CITY COUNCIL AGENDA ITEM

CITY OF SHORELINE, WASHINGTON

AGENDA TITLE: QUASI-JUDICIAL: Action on Preliminary Formal Unit Lot Subdivision No. PLN20-0139, Dividing Eleven (11) Existing Parcels into Seventy (70) Unit Lots at 2105, 2117, and 2123 N 148th Street; 2116, 2122, 2132, 2142, and 2150 N 147th Street; 14704, 14710 and 14718 Meridian Avenue N (East side of Meridian Avenue N, between N 147th and 148th Streets)

TREE PROTECTION PLAN

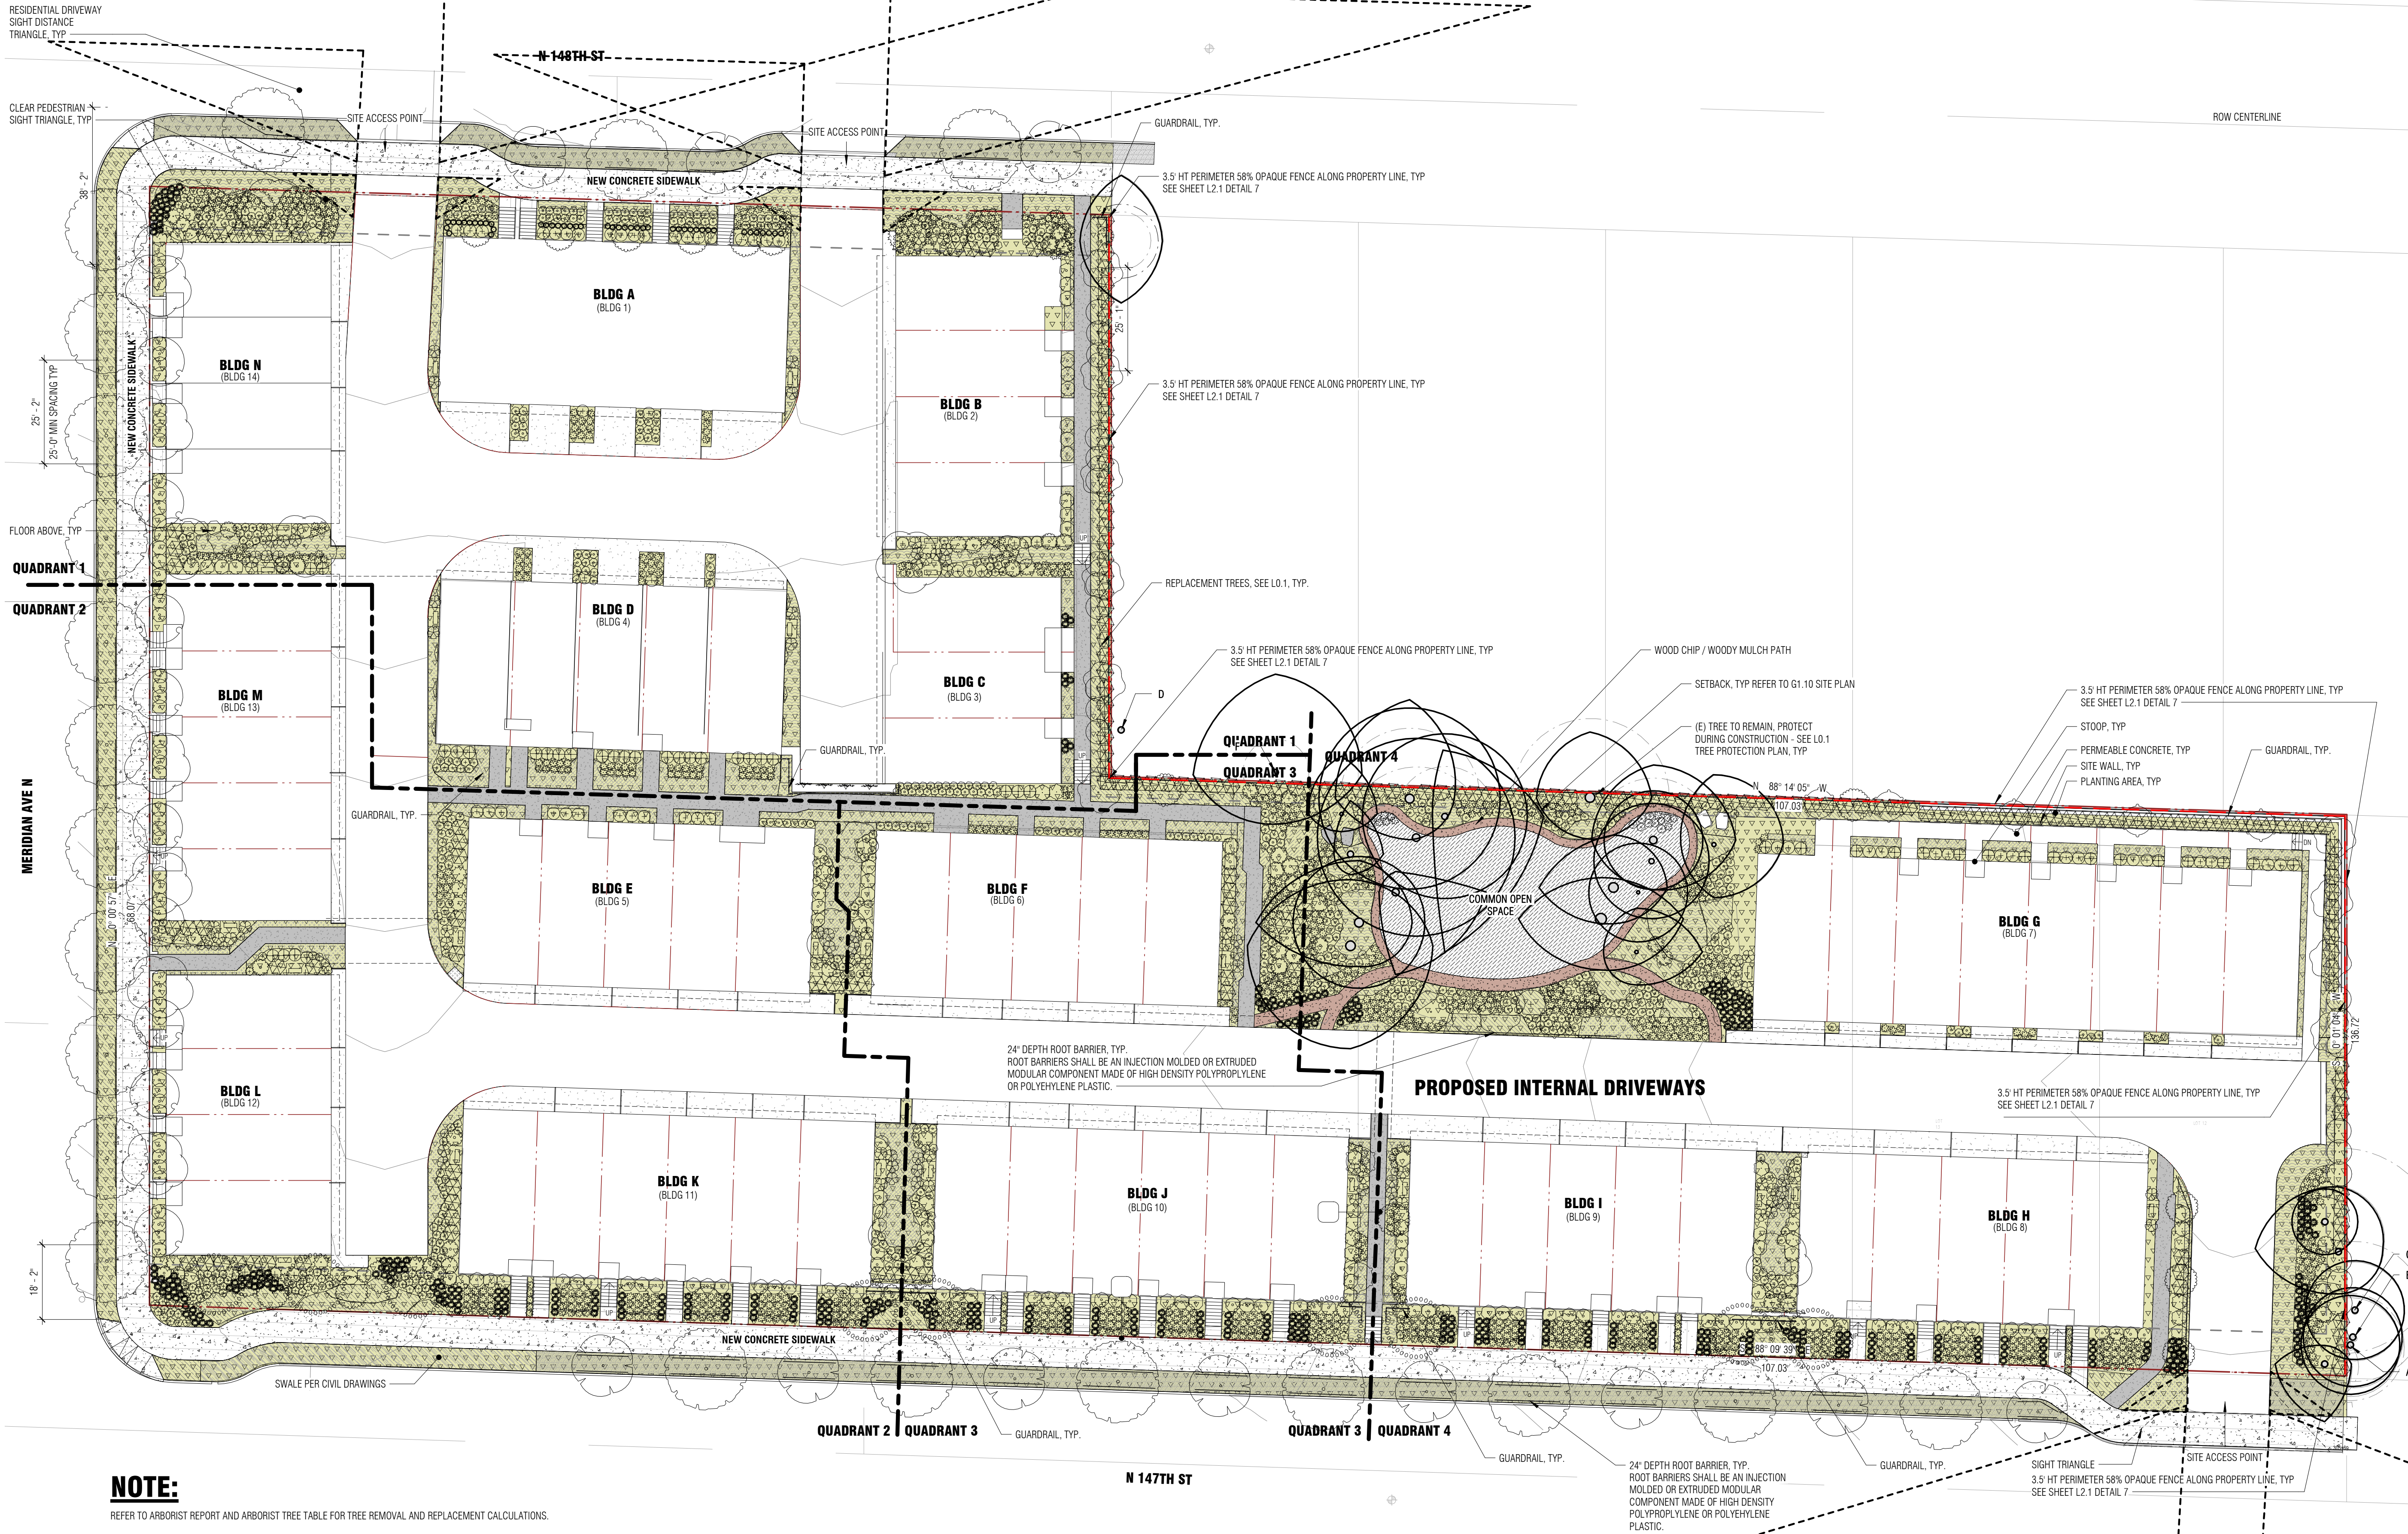
26. There are three trees labeled #98 on Sheet L0.1. Please clarify/correct plans. I recommend doing a quality control check before submitting the next revisions to make sure there are no other instances like this—when I do my follow-up site visit for trees items like this should be addressed.

28 C. The arborist report states that a 9-foot TPZ is needed for Tree E, but Sheet L0.1 shows only a 7-foot TPZ is provided. Revise plans to comply with arborist report.

31. There are still issues with trees proposed for retention being adequately protected per the arborist report and what is shown on Sheet L0.1. See table below. Please address these discrepancies in updated plans/arborist addendum.
